## Application for <u>Waiver from Construction Standards</u> for Public Water Systems

Water System Name	Tualatin Valley Water District	PWS ID	00655
Project or Facility	C12913-SW 92 <sup>nd</sup> Ave (Greenburg to N	Dakota) County	Washington
Need for waiver iden	itified: 🗌 Water System Survey	Date of Survey	2/19/2025
	Plan Review #

Construction standard requested to be waived: OAR 333-061-0050 (9) (d)

Cross-section looking East at connection point between existing 6" that runs E-W along SW North Dakota St and new 6"/8" that runs N-S along SW 92nd Ave

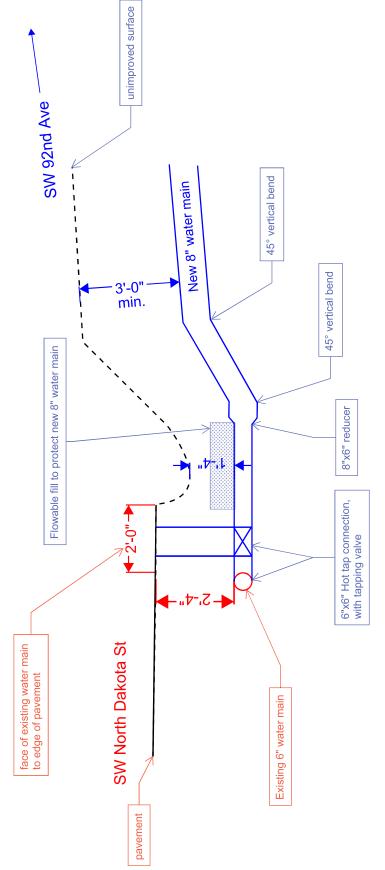
Describe situation that conflicts with the standard. While potholing for the existing water main on 2/19/25, along SW North Dakota St., we discovered that the main we needed to tie into is located just 2 feet from the south edge of the pavement. Due to the hot tap connection and required tapping valve, the new north-to-south main could not achieve the minimum cover requirement, even with vertical bends installed, as the drainage ditch south of the edge of paving causes a significant drop in topography immediately after the connection point. As a result, the cover depth of the new main within the drainage ditch is 17 inches. Please see the attached sketch for reference.

Describe why meeting the standard is highly burdensome or impractical. Meeting the standard is impractical because, even with vertical bends, the main would not meet OAR cover requirements in the ditch due to the connection point's close proximity to the drop-off.

Describe proposed alternate measure that provide adequate protection to public health and safety. To protect the main at shallow cover points, flowable fill was placed above it. TVWD has also documented the issue in our mapping system for correction when the water main that runs along SW North Dakota St. is replaced.

OAR 333-061-0050 is hereby:	<b>a</b>		
X Approved		e pipe will be encased with CLSM, then rock ab	ove
Denied	to	surface to minimize erosion.
